Architectural Drawings SSDA RtS

2b-6 Hassall Street
Parramatta

Charter Hall and Western Sydney University

August 2019

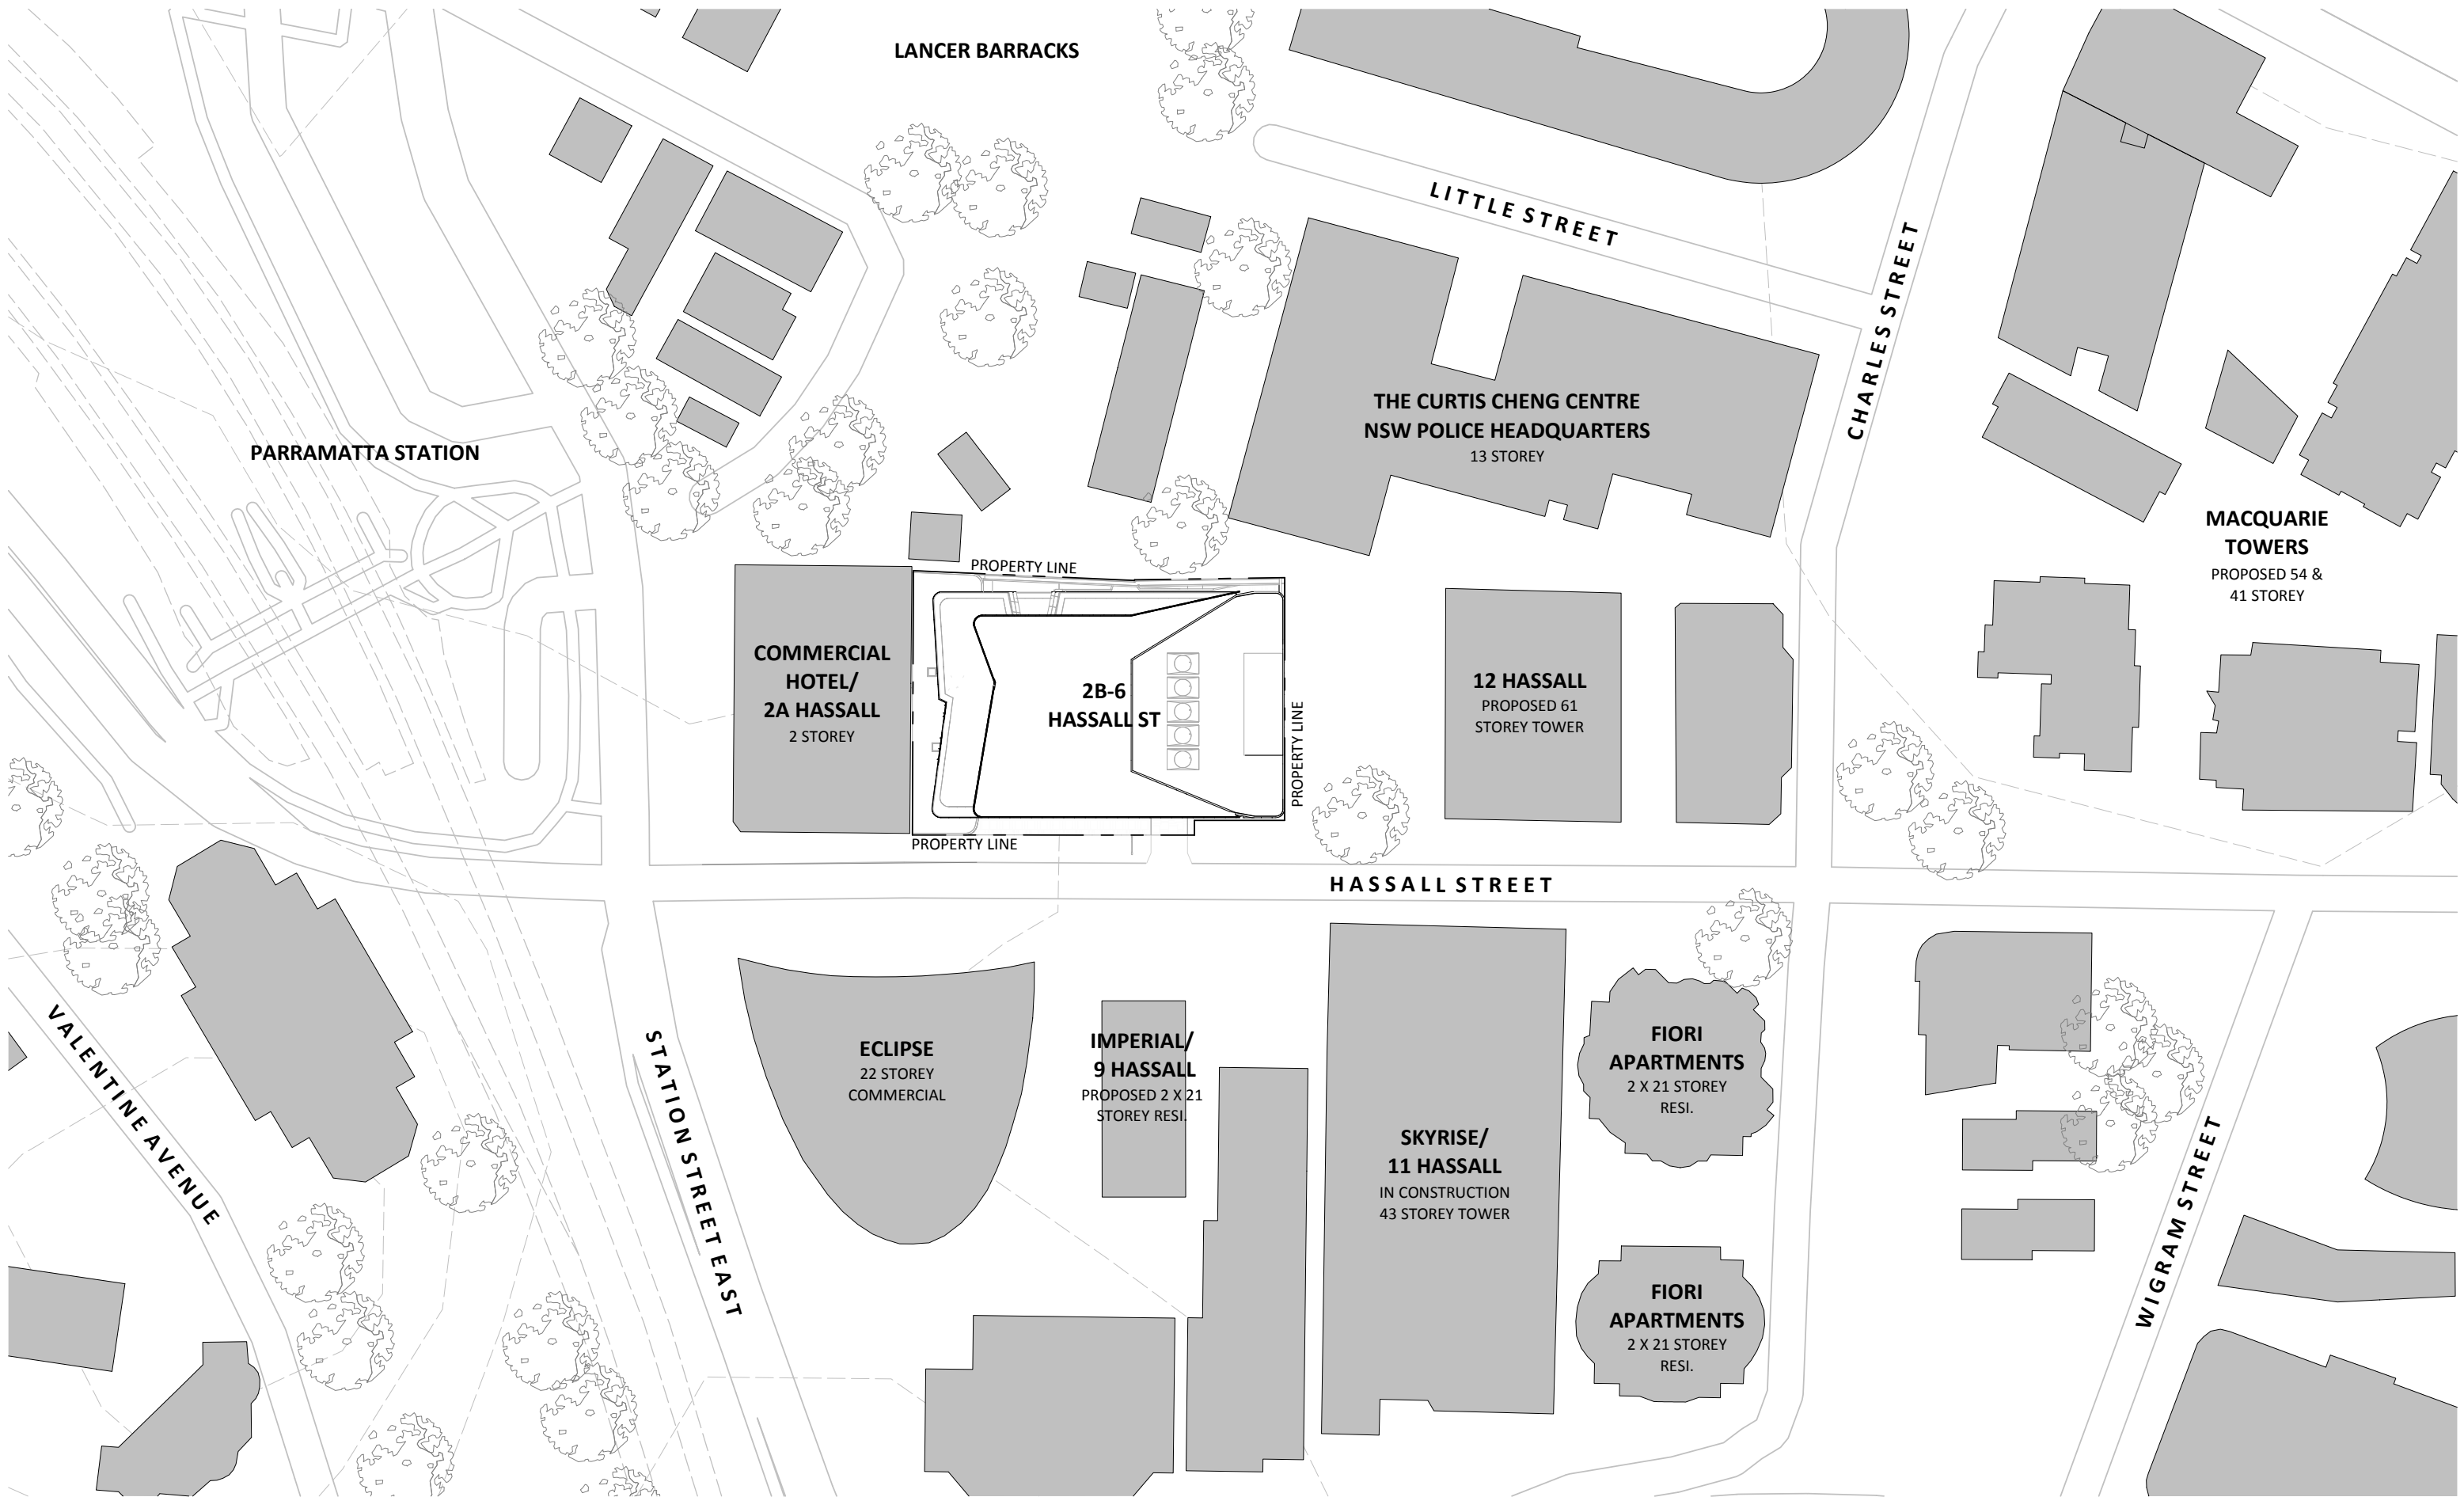
SCHEDULE OF CHANGES			
LEVEL/ DRAWING NO.	CLOUD NO.	CHANGE DESCRIPTION	CORRESPONDING EU RESPONSE SCHEDULE NO.
BASEMENT/ 10.00	1	- WSU floor space reconfigured and refined - Amphitheater steps reorientated - Layout of plant and back-of-house facilities refined - Inclusion of basement shuttle lift	-
	2	Parking schedule updated (2 new car parking bays)	-
GROUND FLOOR/ 10.01	3	Note added to refer to Landscape drawings for shoreline strategy	CoP 2c
	4	- Bike parking racks relocated - Existing light pole added	CoP 2d, 2f
	5	Note added for expansion joint to property line	CoP 2h
	6	Finishes tag added to columns and paving for luminous contrast	CoP 3e
	7	- Retail RLs and Plaza RLs added to achieve flush threshold to retail entries - Dimension added to Retail entry doors - Dimension added for latch side clearance to DDA bathroom - Rationalised retail building form and tenancy areas	CoP 3a, 3b, 3c
			CoP 3a, 3b, 3c

Sheet Name
RCP - LEVEL 02

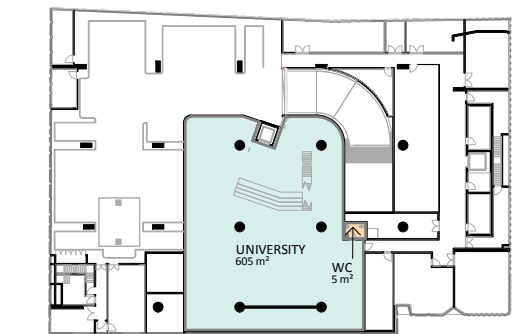
8	Revised Lancer Barracks steps for improved activation and engagement and for future proofing through site link	CoP 2a
	9	- Amphitheater steps reorientated - Inclusion of shuttle lift to basement	-
	10	- Sloped lift lobby rationalised - Steps and platform lift added - Deletion of lobby cafe space	-
LEVEL 01/ 10.02	12	Planter to retail roof revised to suit rationalised retail building form	-
LEVEL 10/ 10.07	13	- Terrace door dimension added - Threshold detail tag added	CoP 4a, 4b
LEVEL 12/ 10.09	14	- Terrace door dimension added - Threshold detail tag added	CoP 4a, 4b
LEVEL 19/ 10.12 ROOF/ 10.13 COOLING TOWER/ 80.00	15	Rationalised cooling tower enclosure	-
RCP LEVEL 12 / 11.03	16	Ceiling Legend added to clarify ceiling and soffit finishes	-

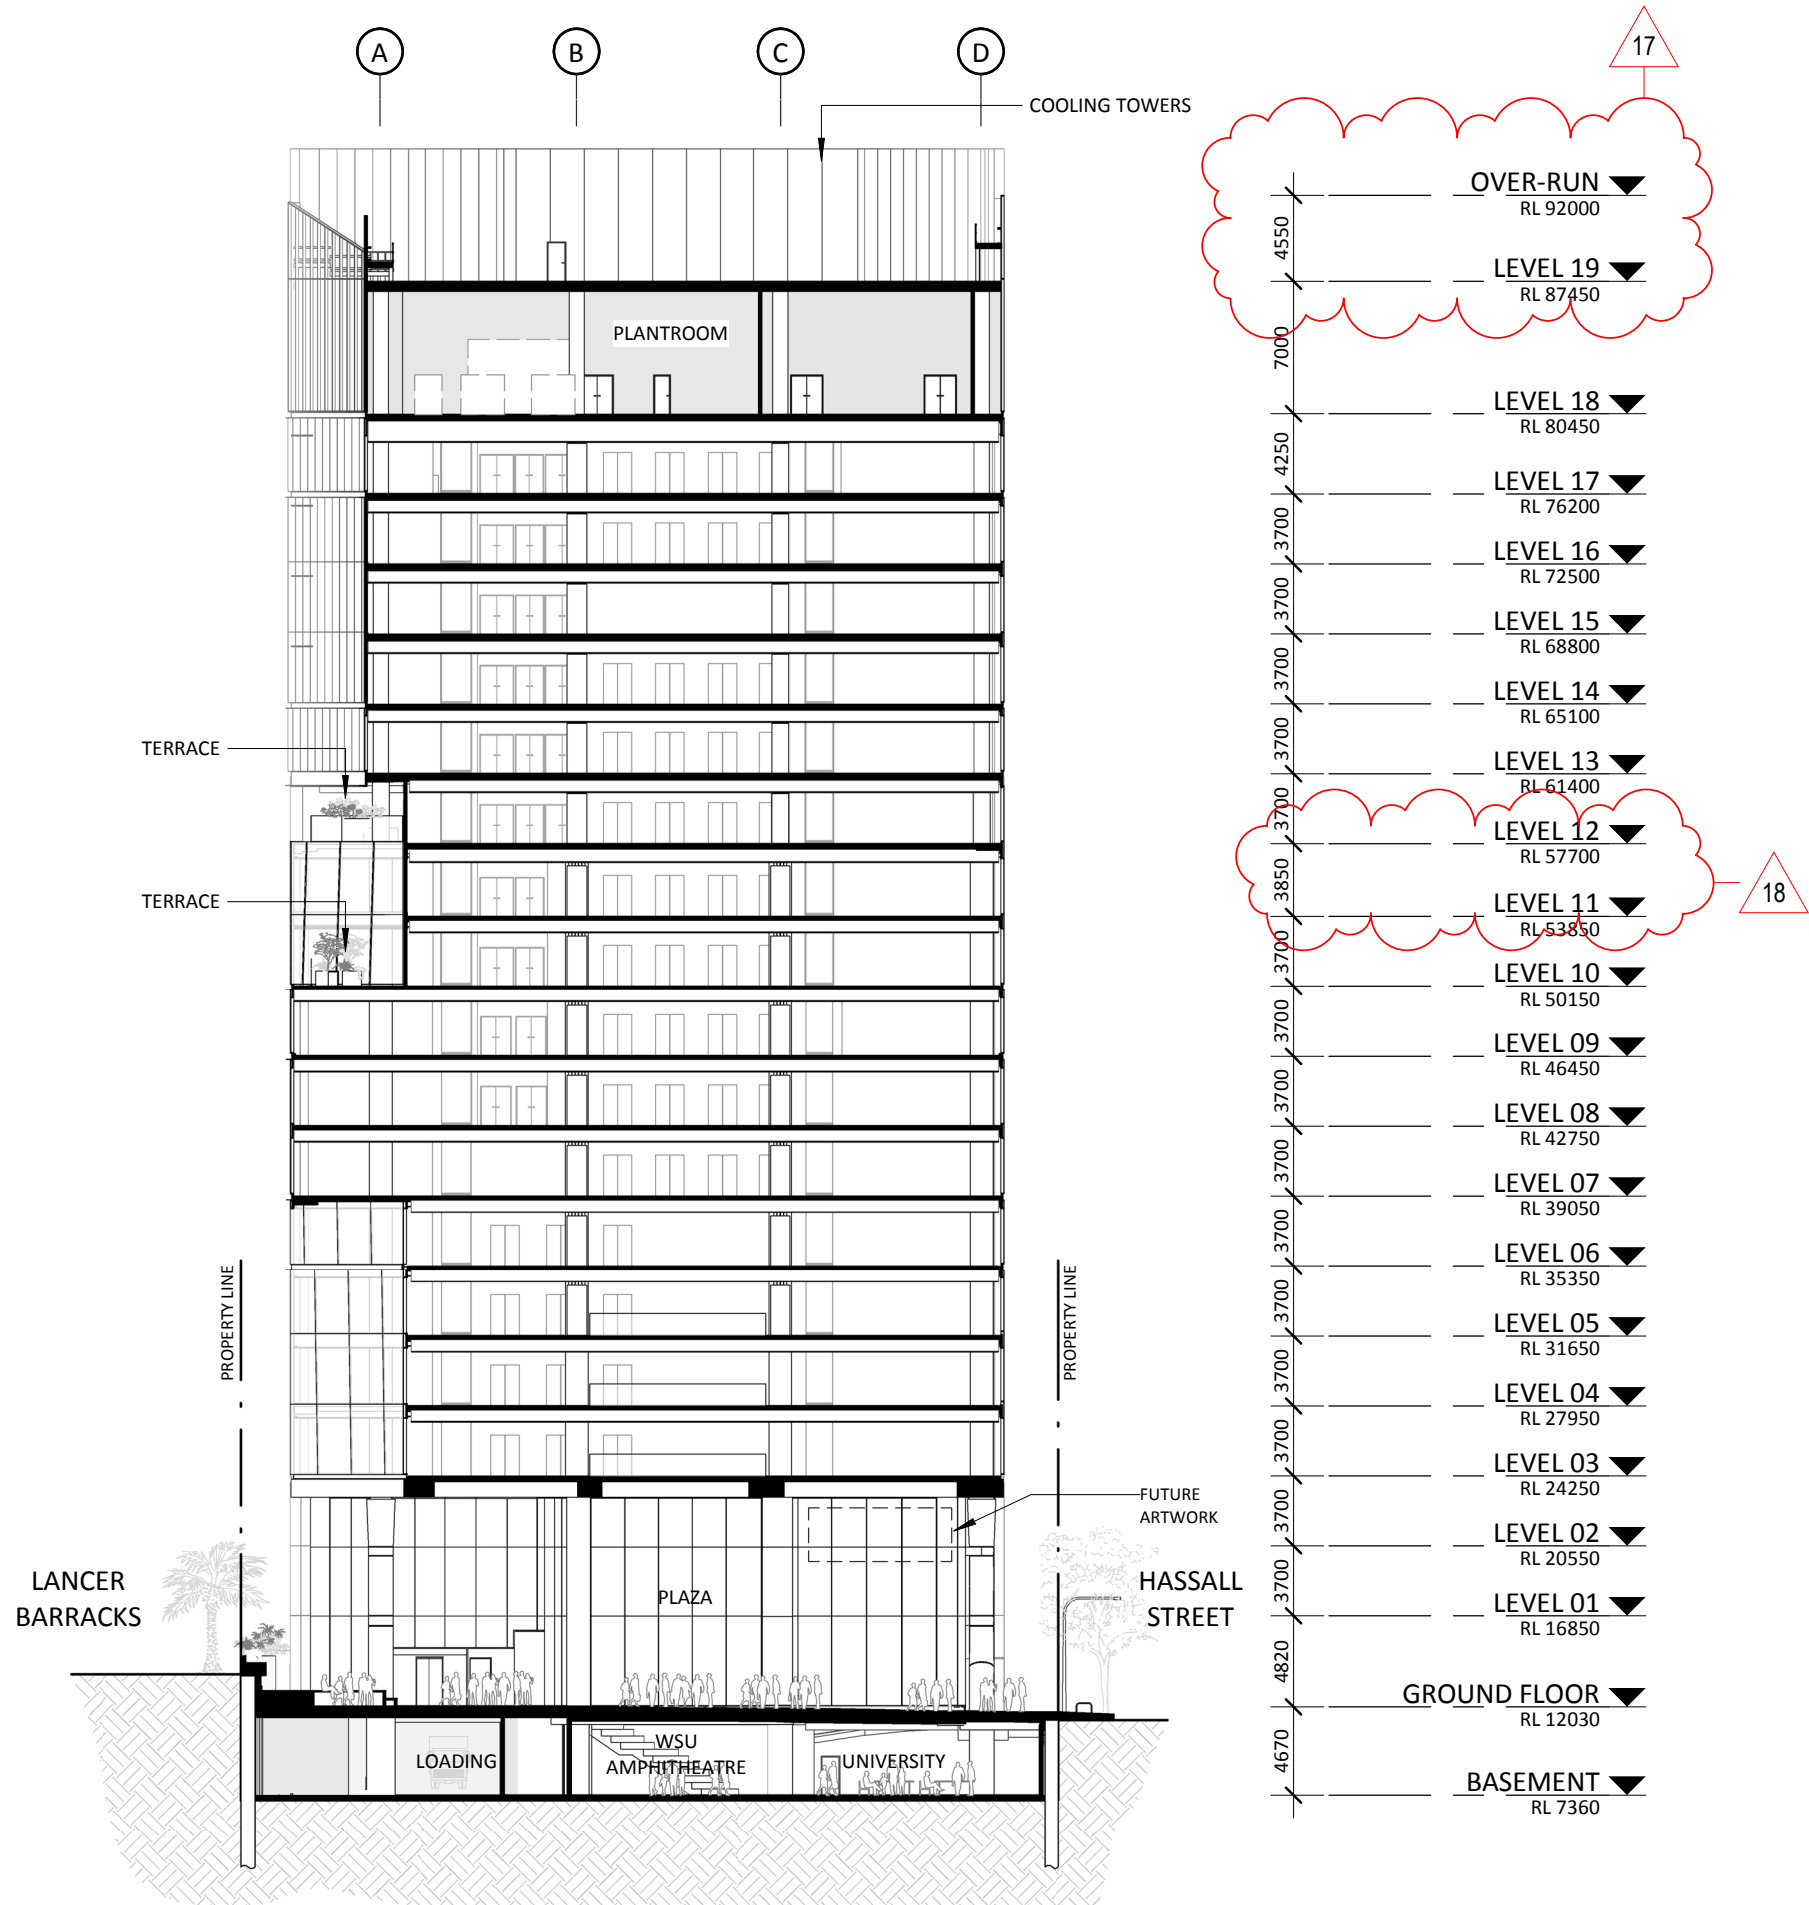
LEVEL/ DRAWING NO.	CLOUD NO.	CHANGE DESCRIPTION	CORRESPONDING EU RESPONSE SCHEDULE NO.
SECTION A/ 20.00 SECTION B/ 20.01 NORTH ELEVATION/ 30.00 EAST ELEVATION/ 30.01 SOUTH ELEVATION/ 30.02 WEST ELEVATION/ 30.03	17	Lift over-run height adjusted	-
	18	Floor to floor height adjusted to allow flush threshold access to L12 terrace	CoP 4a
	19	Façade finishes schedule updated	-
	20	Building height rationalised	-
	21	Proposed height of cooling tower enclosure	-
	22	- Core finishes clarified to allow for flexibility of construction - Finish to be precast concrete panels and/or off form concrete	-
	23	Horizontal louvre for general exhaust added	-
TYPICAL TERRACE DOOR DETAILS / 52.05	24	Threshold details added	CoP 4a
EXTERNAL FINISHES SCHEDULE/ 60.01	25	See Cloud No. 22	-
